UNITED STATES OF AMERICA
NUCLEAR REGULATORY COMMISSION
BEFORE THE ATOMIC SAFETY & LICENSING BOARD

| (Turkey Point Nuclear Generating Station, Unit Nos. 3 and 4) |) | June 28, 2019 |
| (Subsequent License Renewal Application) |) | |

**DECLARATION OF E.J. WEXLER IN SUPPORT OF
THE FRIENDS OF THE EARTH, NATURAL RESOURCES DEFENSE COUNCIL &
MIAMI WATERKEEPER**

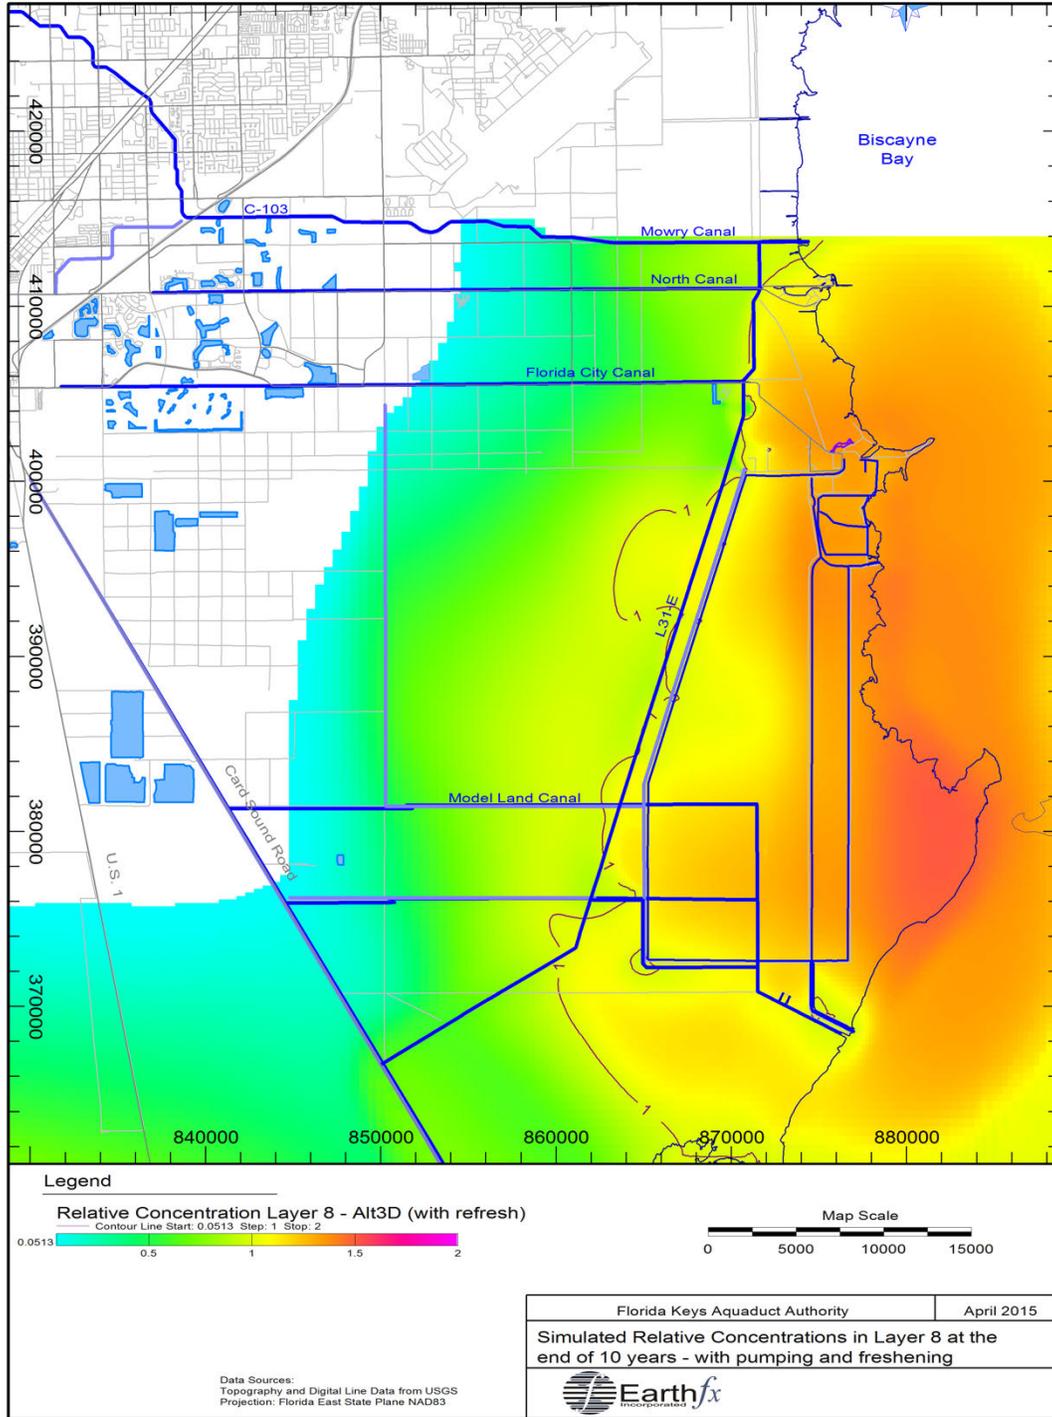
in Layer 8 (the “Lower High Flow zone” in the Tetra Tech (2016a) model) for the baseline conditions (pumping and freshening) are shown in Figure 1. The 1.0 relative salinity contour represents seawater salinity and is mostly near the CCS boundary. Results without freshening are shown in Figure 2 and show the 1.0 contour as much as 12,000 ft west of the CCS. These results indicate that, without being able to achieve freshening at the current time or in the future, the retraction of the hypersaline water is not likely to occur without the addition of more wells and increased pumped volumes. More analysis would be required to determine whether the additional withdrawals would have harmful effects and the additional water may, therefore, be unavailable. Thus despite the considerable lead time cited in the draft SEIS, groundwater remediation and improvement may not be possible prior to the subsequent period of extended operations without significant changes to the CCS operations and recovery well system.

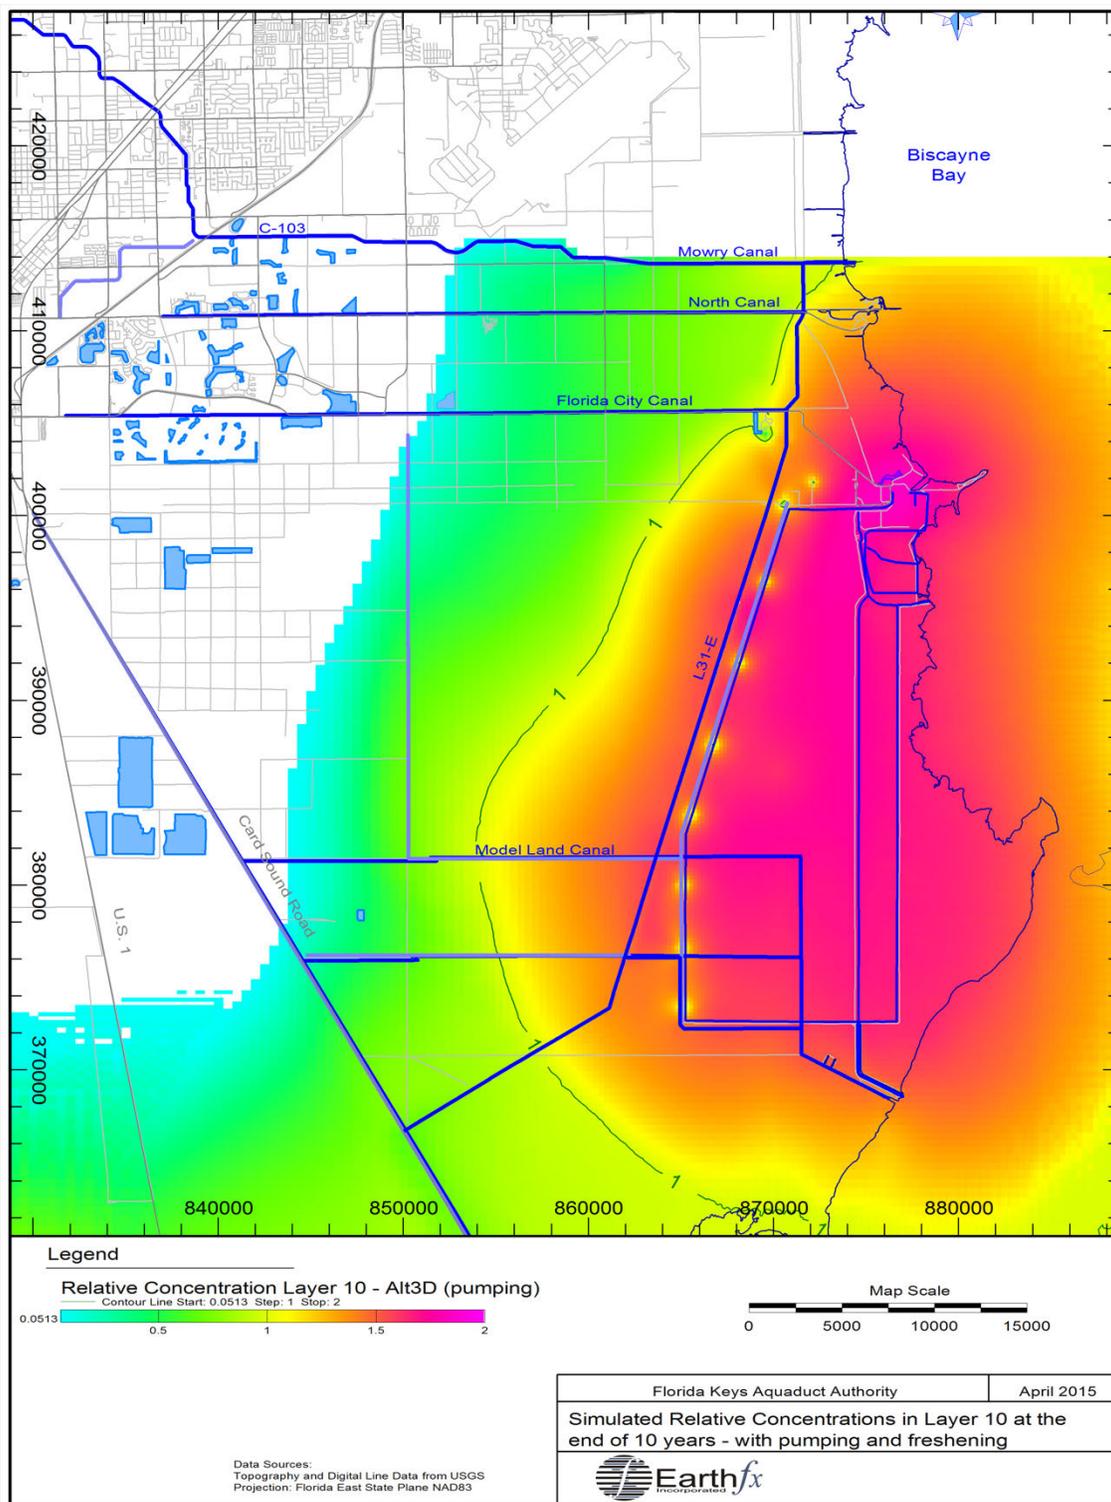
It should be also be noted that the FPL models (Tetra Tech, 2016a, 2016b, and 2017) showed that pumping would not pull the hypersaline plume back in the deeper layers (e.g., model Layer 10 near the aquifer base) within the 10 year period despite that pump screens being located in the deep layers. Figure 3 shows the simulated concentrations in the Layer 10 after 10 years of pumping and freshening. The concentrations within and west of the CCS remain above sea water concentrations. These results indicate again that meeting the 2016 consent order with FDEP is not achievable with the number of wells and pumping volumes proposed.

Figure 4: Hydraulic conductivity values assumed for Layer 8 (Lower High Flow Zone) in the Tetra Tech (2017) model.

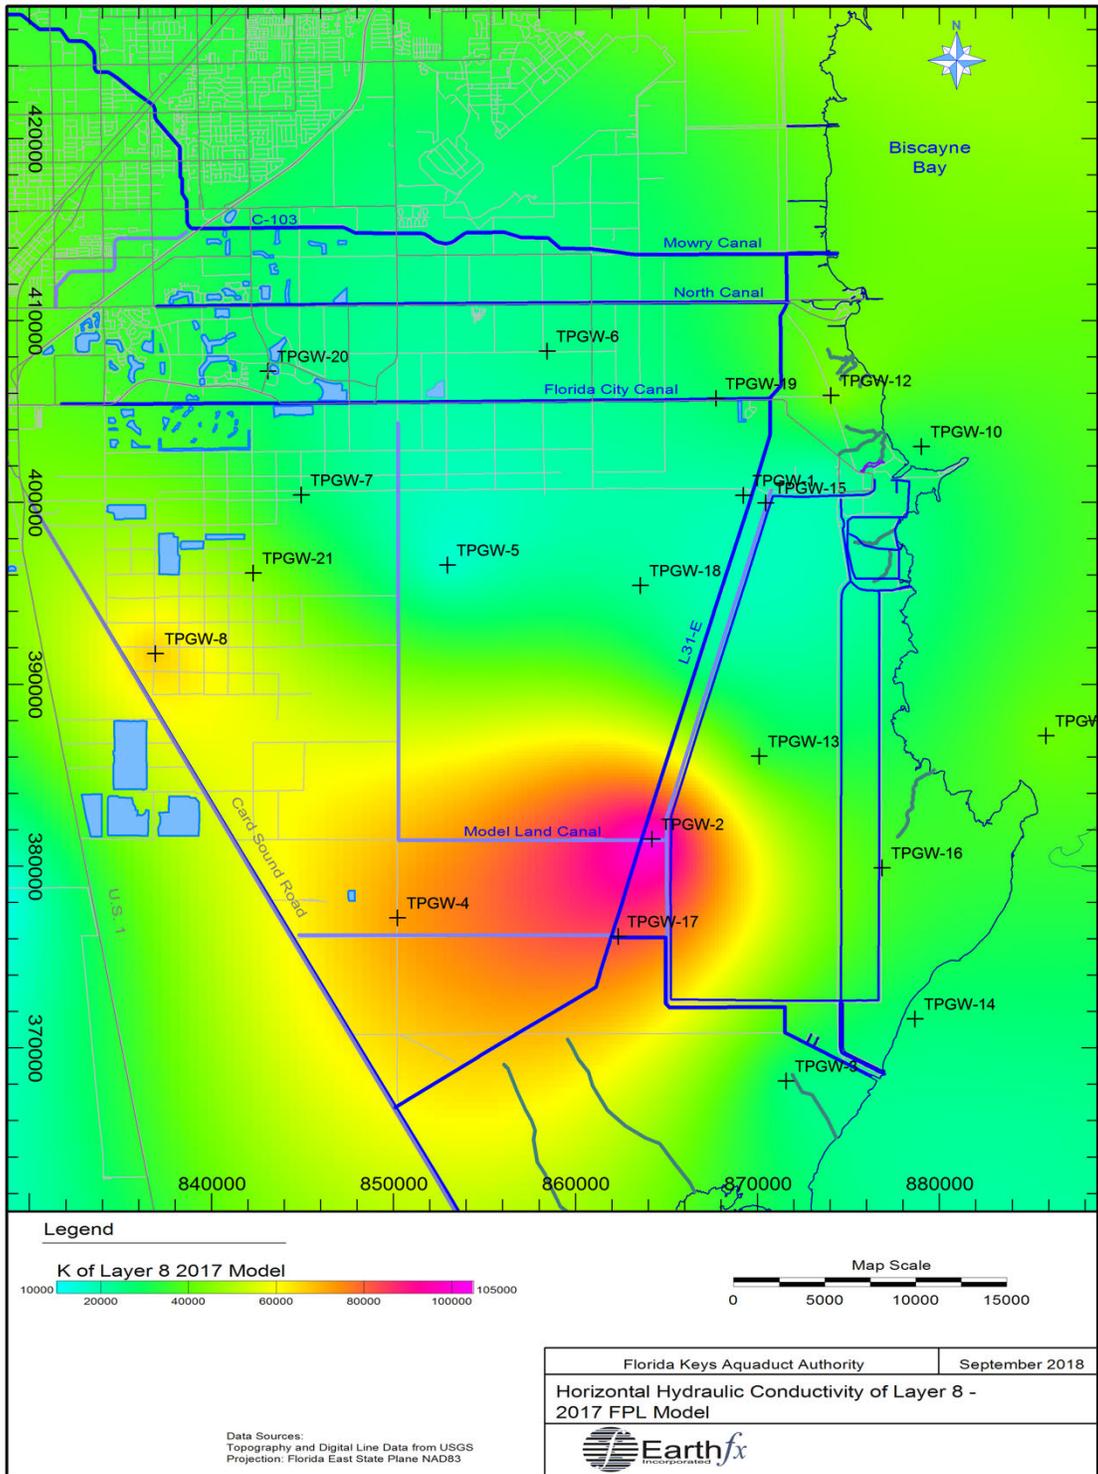
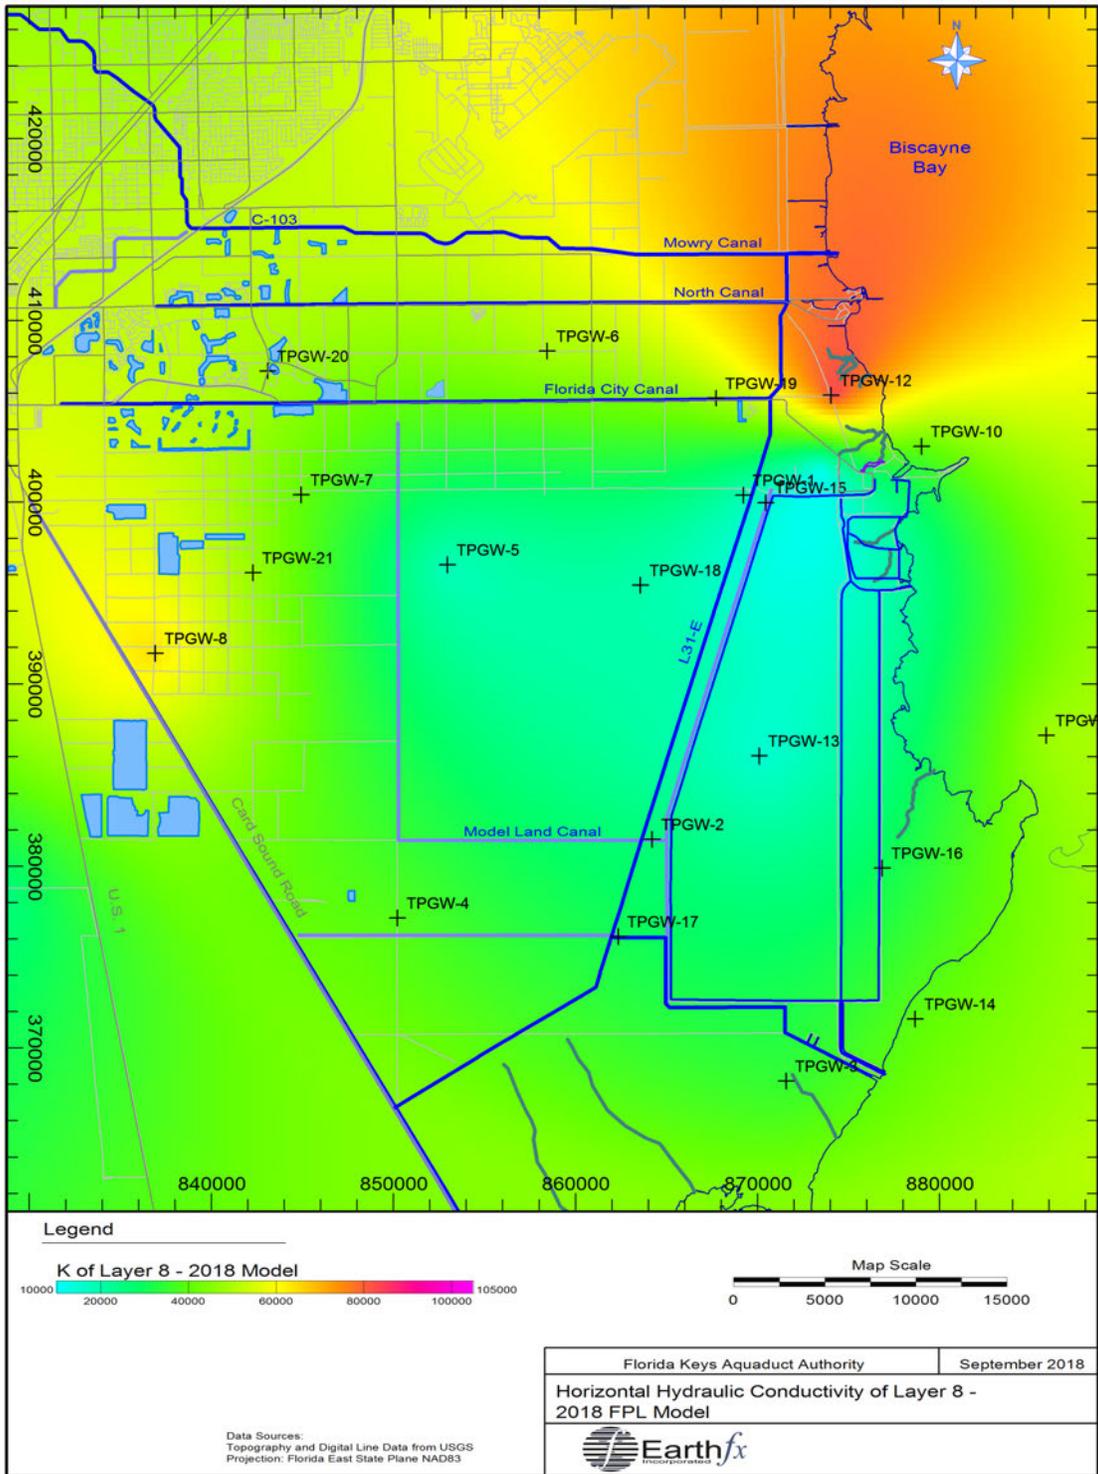
In particular, the horizontal hydraulic conductivity values have been changed from the previous (2017 update) model, with the newer values being generally higher. The spatial distribution of the high and low hydraulic conductivity values within Layer 8 (the most permeable layer) has been altered significantly. The zone of high hydraulic conductivity in the southwest part of the CCS (centered between TPGW-2 and TPGW-17) (shown in Figure 4) has been removed and relatively low values are assigned below the CCS and to the west in the 2018 model (Figure 5). This results in reduced westward migration of hypersaline water in the 2018 analyses. Layer 8 contributes the most to the transmissivity of the Fort Thompson Formation (the high permeability unit forming the principal part of the Biscayne Aquifer) and significant changes in transmissivity of this unit can be seen. Figure 6 shows the transmissivity of the Fort Thompson Formation (model Layers 3 to 11) in the Tetra Tech (2017) model (Figure 7), in thousands of ft²/d with a zone of high transmissivity within the southwestern part of the CCS. Figure 8 shows the transmissivity of the Fort Thompson Formation with the high transmissivity zone absent. Transmissivities west of Card Sound Road are generally higher in the 2018 model but still well below the observed values (e.g., Fish and Stewart, 1991 or Hughes and White, 2014).

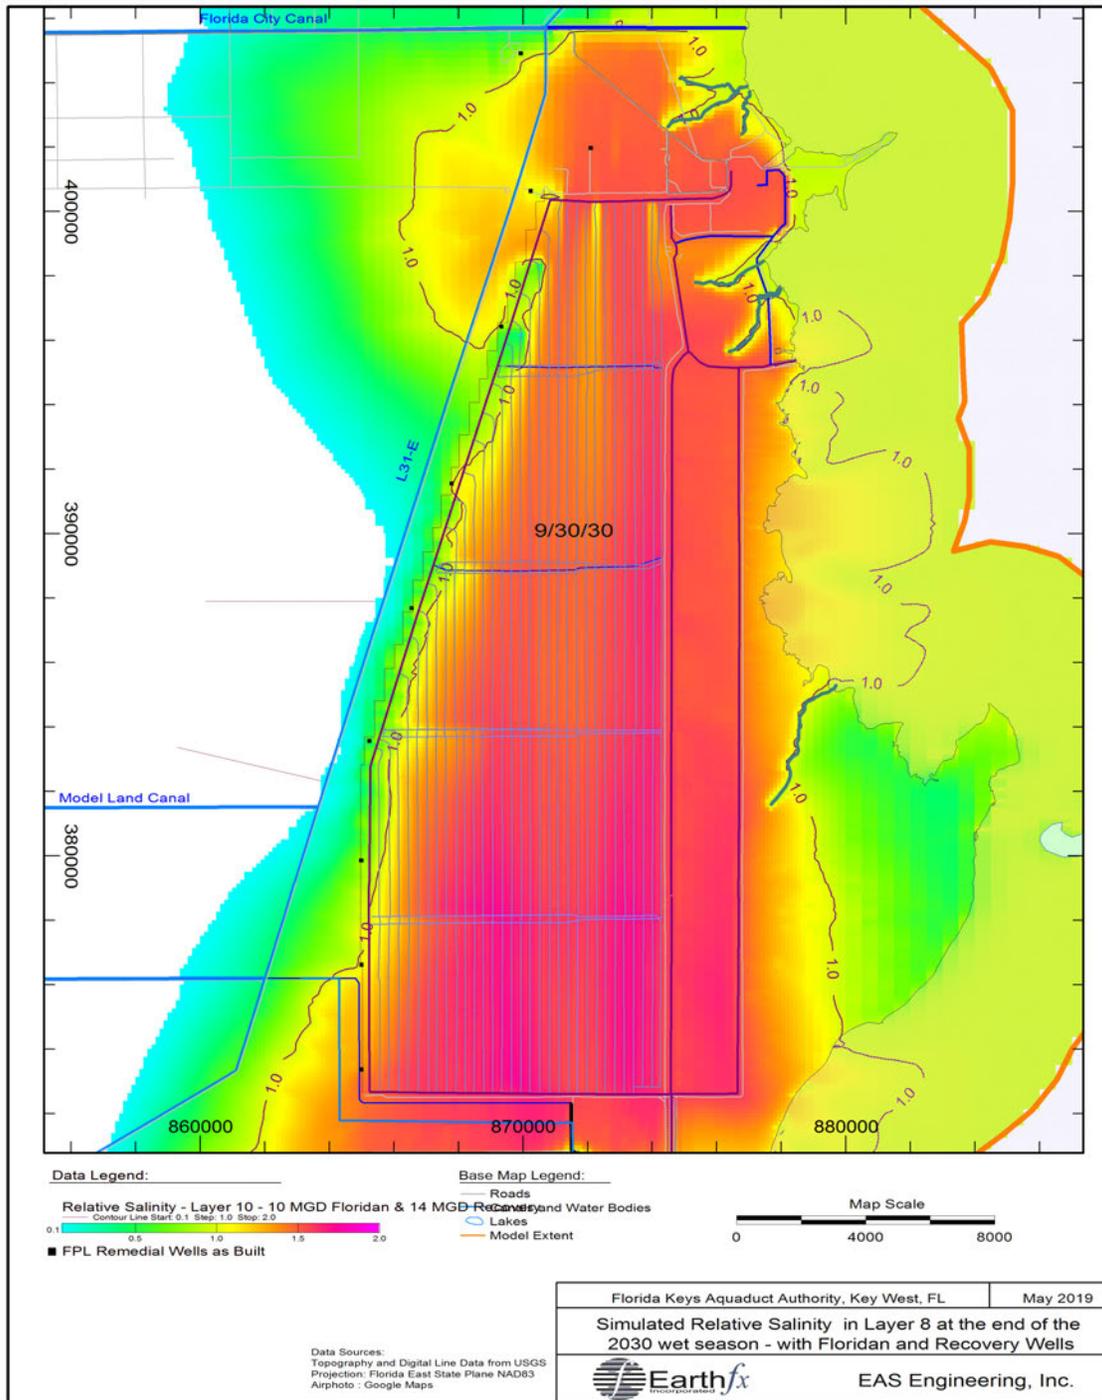
As part of this review, I developed a more refined model of the study area that attempted to better represent flow in the CCS and the effect of evaporation and adding water to the CCS. Key features of the model are described in a draft report (Earthfx, 2019). Simulations of future conditions were conducted with flow in the CCS, evaporation, and the introduction of 10 MGD of Floridan water and 14 MGD from the recovery wells. The recirculation of water option was used in SEAWAT to estimate the concentrations of the recovery well water and to represent the recirculation of water through the plant. Concentrations vary over time from the starting conditions (about 1.71 relative salinity (60 PSU)) and reach a relative equilibrium by 2028. Simulated concentrations are shown in Figure 8 and indicate that placement of the Floridan and recovery water along the west side of the CCS has helped in preventing movement of the hypersaline water over most of the western boundary of the CCS but the bulk of the CCS is still hypersaline and a breakout zone occurs in the northeast corner due to the higher water levels in that area.
